Item Name: Crosstube Turning Detail

DART AEROSPACE LTD		Work Order: 73252
Description: Crosstube Assembly (205/212 High Aft)		Part Number: D212-664-241
Inspection Dwg: D212-664-241 Rev: D		Page 1 of 1

DRAWING NO. D212-664-241	TITLE CROSSTUBE ASSY (205/212 HI AFT)	REV. D	DART AEROSPACE LTD. ENGINEERING ORDER		D.E.O. NO. D212-664-241-D-1	SHEET NO. SHEET 1 OF 2	SCALE NTS
DRAWN	CHECKED		MFG. APPR.		APPROVED	DE APPR.	
DATE 11.04.07	DATE 11.04.11		DATE 11.04.12		DATE 11/04/12	DATE 11.04.12

DRAWING NO. D212-664-241	TITLE CROSSTUBE ASS'Y (205/212 HI AFT)	REV. D	DART AEROSPACE LTD ENGINEERING ORDER		D.E.O. NO. D212-664-241-D-2	SHEET NO. SHEET 1 OF 1	SCALE NTS
DRAWN <i>q</i>	CHECKED <i>ASS</i>	MFG. APPR. <i>DS</i>	APPROVED <i>MD</i>		DE APPR. <i>HA</i>		
DATE 11.07.15	DATE 11.07.20	DATE 11.07.21	DATE 11/07/21		DATE 11.07.21

D212-664-241/-241B
ASSEMBLY DETAIL

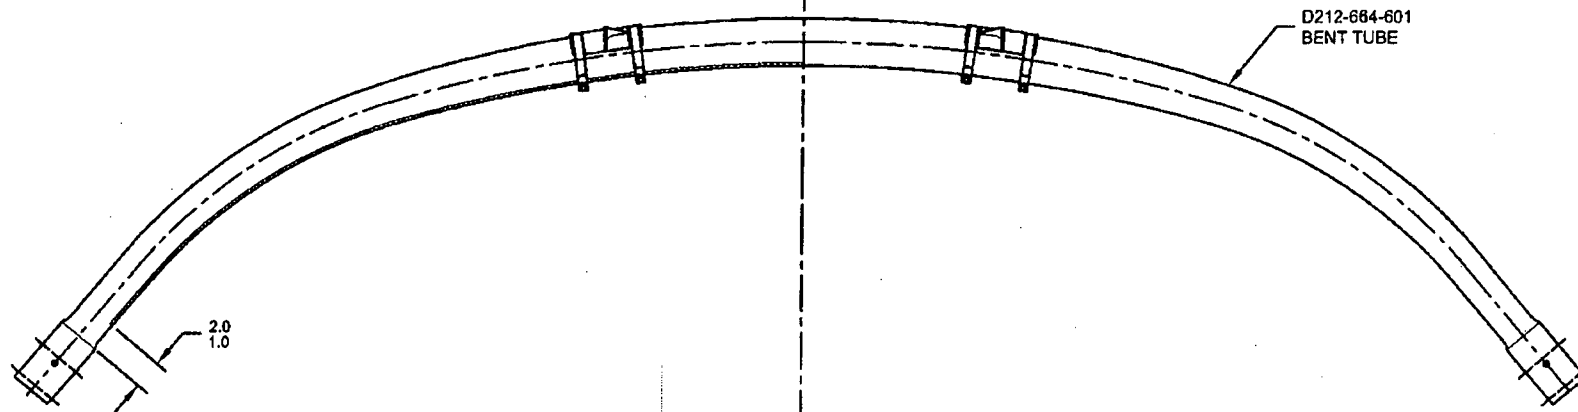
ADD AN INSPECTION WINDOW TO UNDERSIDE OF CROSSTUBE.

- 2) FINISH: CHEMICAL CONVERSION COAT PER DART QSI 005 4.1
PRIME INSIDE AND OUTSIDE PER DART QSI 005 4.2
MASK UNDERSIDE OF CROSSTUBE AS SHOWN (HATCHED AREA) AND
PAINT OUTSIDE PER DART QSI 005 4.2
REMOVE MASKING AND APPLY CLEAR COAT

- 2) FINISH: CHEMICAL CONVERSION COAT PER DART QSI 005 4.1
PRIME INSIDE AND OUTSIDE PER DART QSI 005 4.2
PAINT OUTSIDE PER DART QSI 005 4.2

MASK AREA PRIOR TO PAINTING,
REMOVE MASKING AFTER PAINT
AND APPLY CLEAR COAT
